REVISED
PLAN COMMISSION
MEETING NOTICE AND AGENDA
Thursday, March 18, 2021
7:00 PM
VIRTUAL ONLY

Discussion and Action Regarding a Recommendation to the Common Council for a Conditional Use Permit and Site and Building Plans for Zeilhofer Properties, LLC for Property Located at N4 W22540 Bluemound Road for the Purpose of Constructing a New Freestanding Two-Story Storage Building (PWC 0963997)

Date: February 15, 2021 (3/8/21 - A/E Comments in RED)
To: Mark Wershay, Zimmerman Architectural Studios, Inc.
From: Nick Fuchs, Planner & Community Development Director
RE: Zeilhofer storage building Conditional Use and Site & Building Plan Review

Sheet:
Exterior Elevations

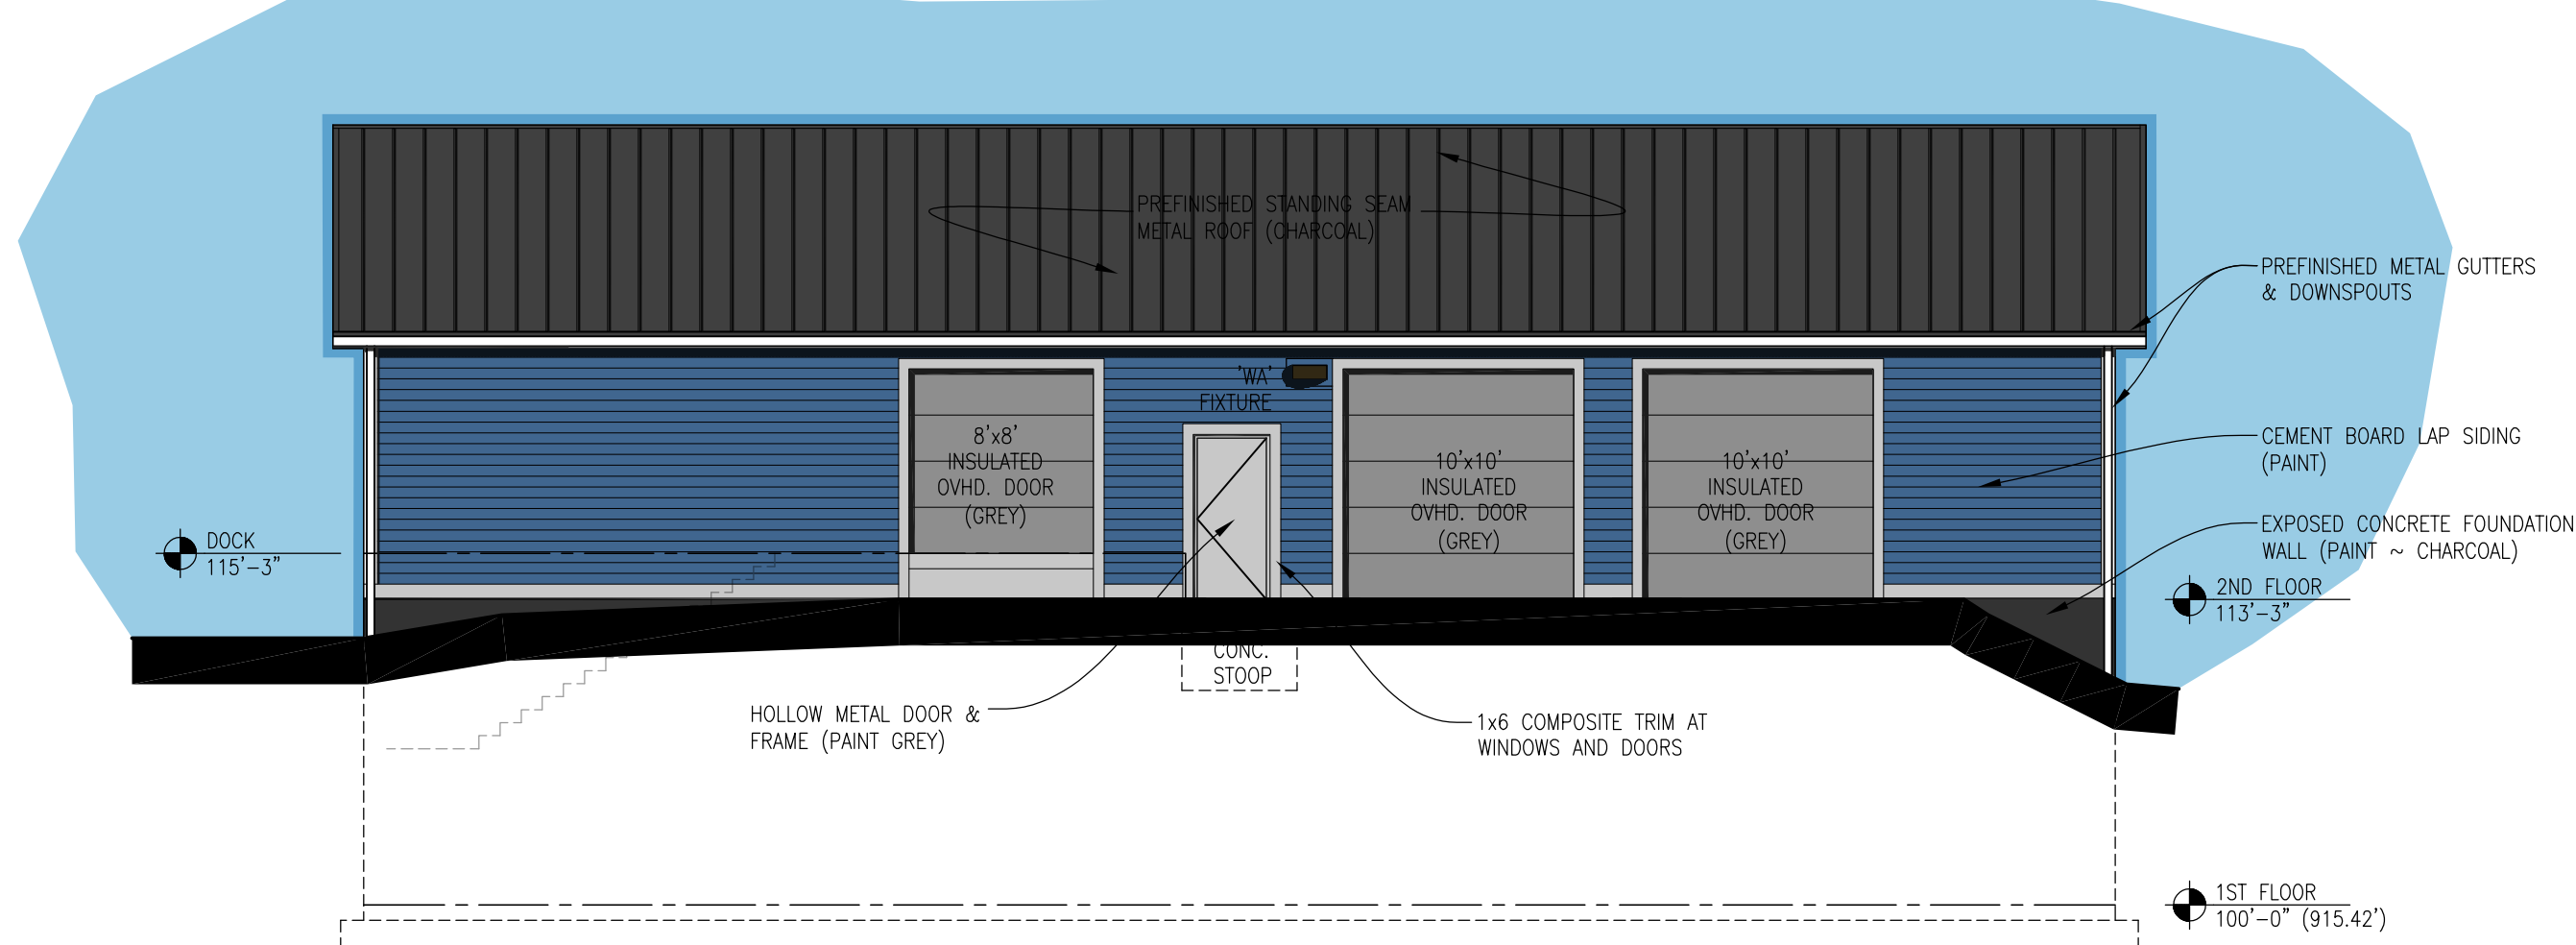
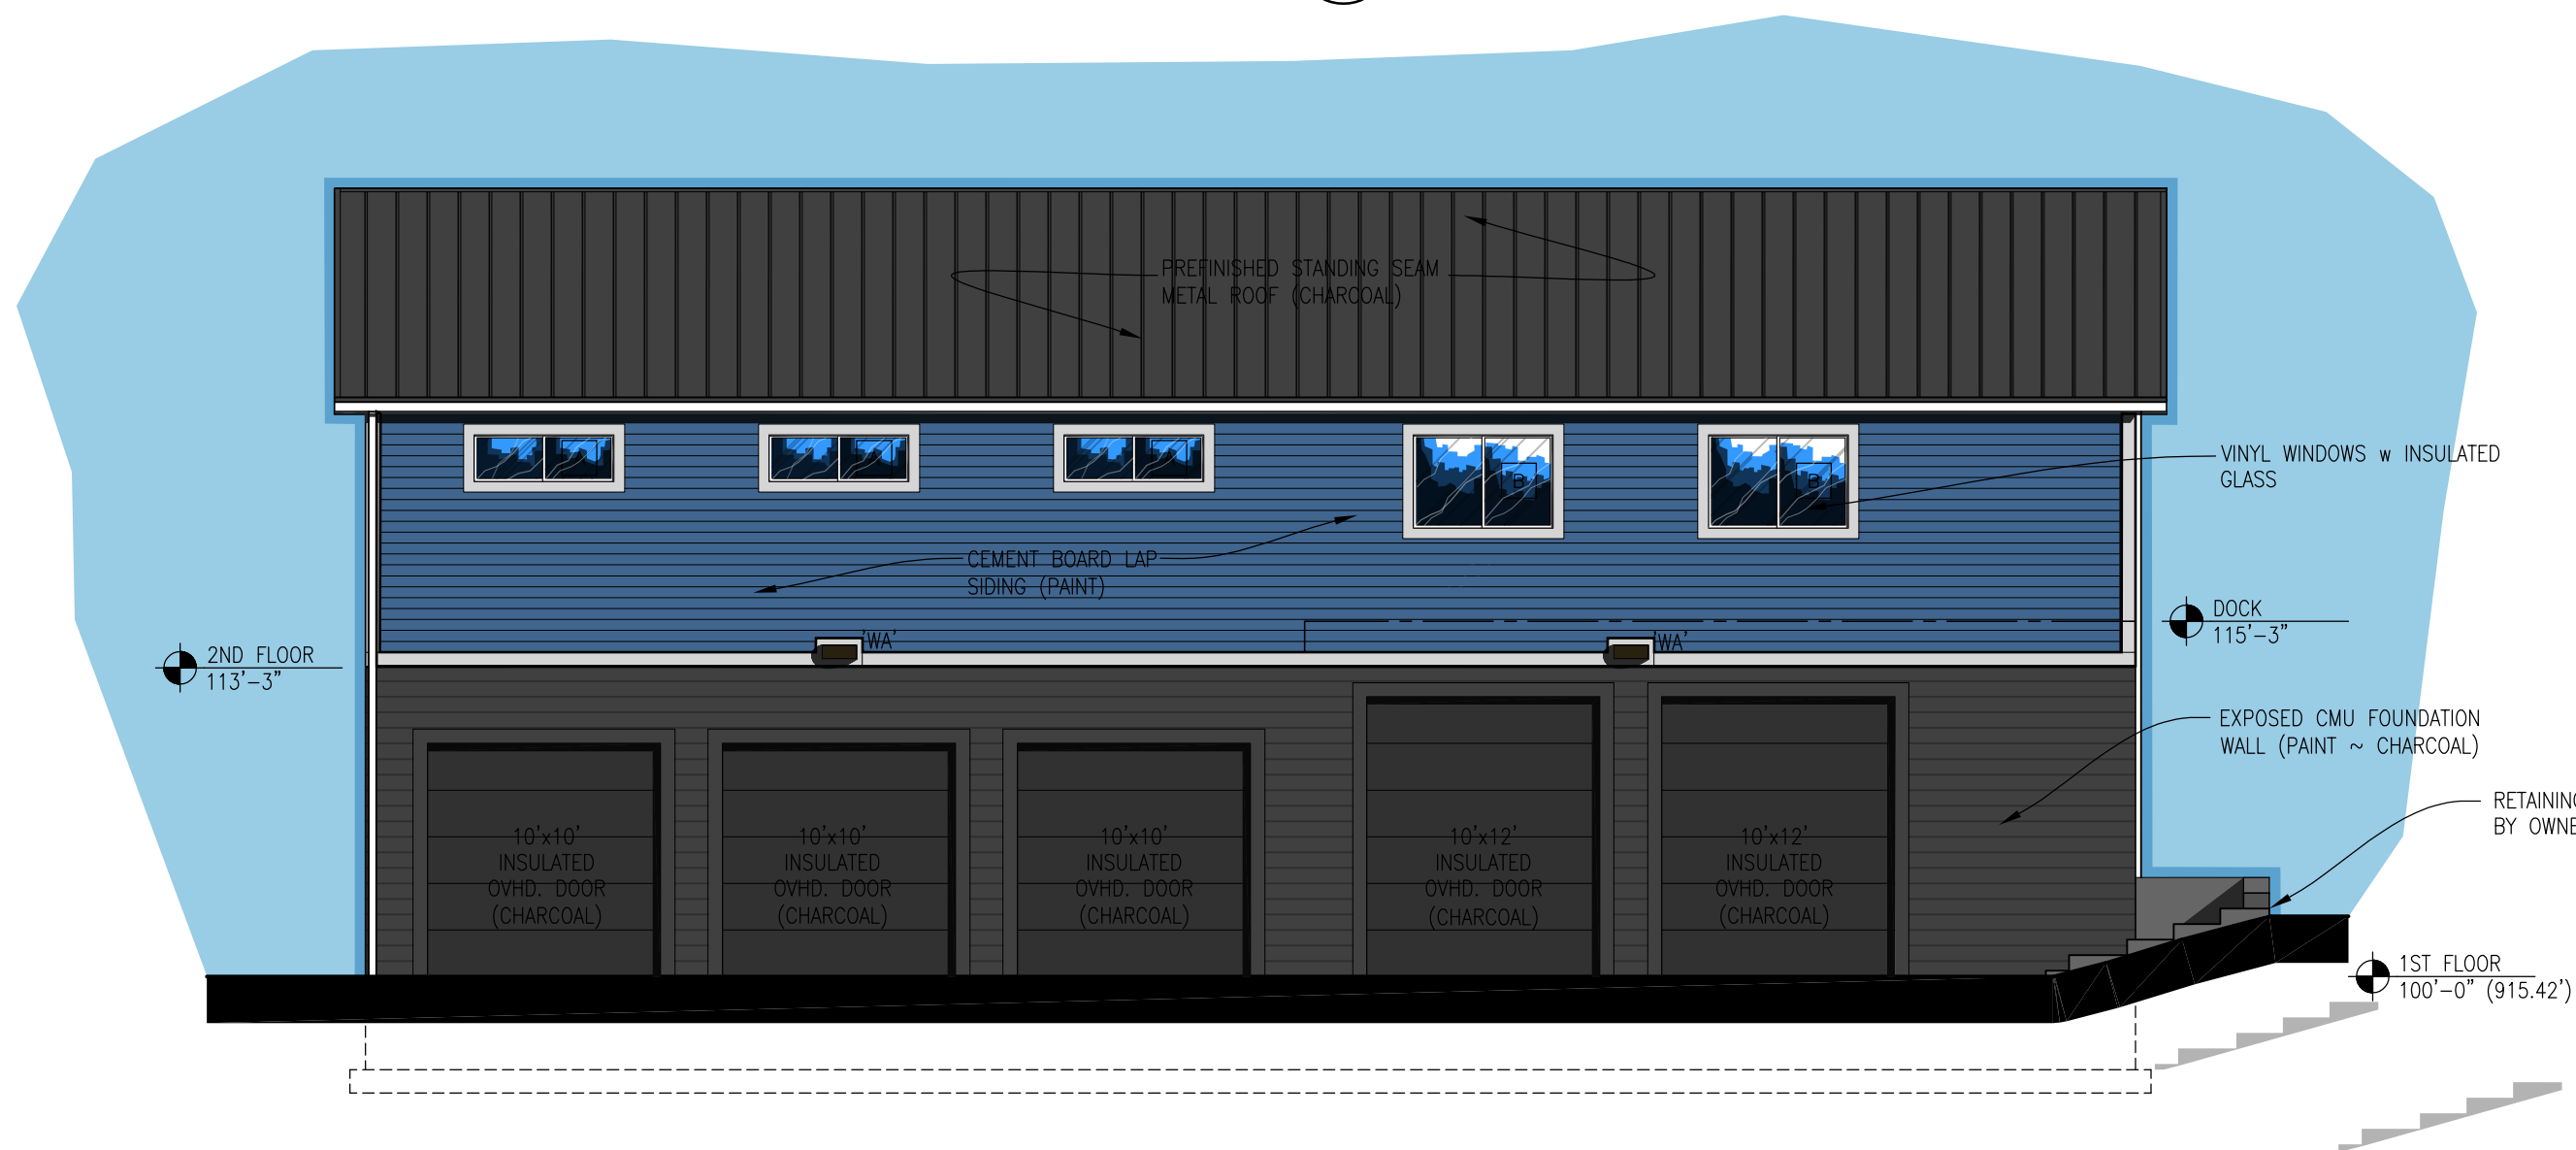
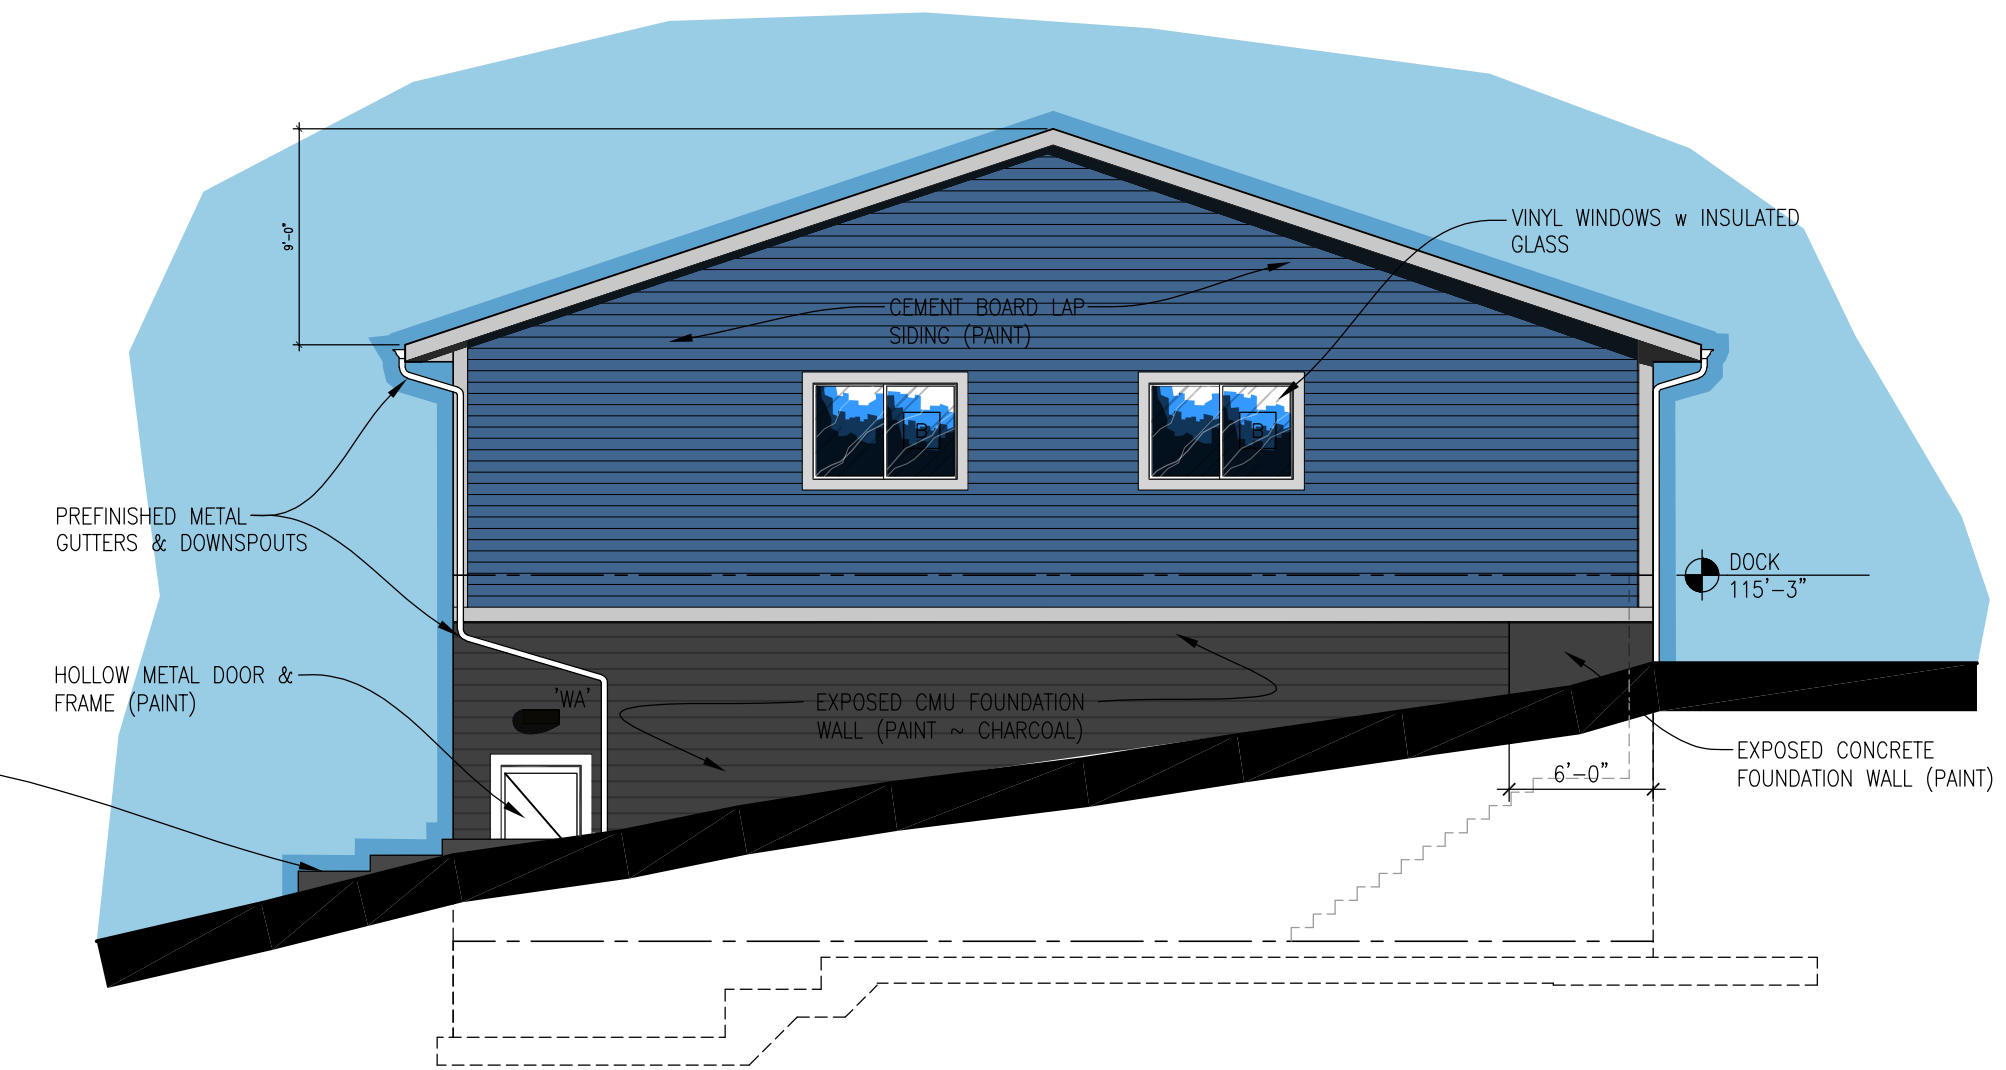
8. What color will the CMU foundation be painted? **Charcoal.**
9. What type of roof material is being used? **Standing seam metal roof as noted on the plans.**
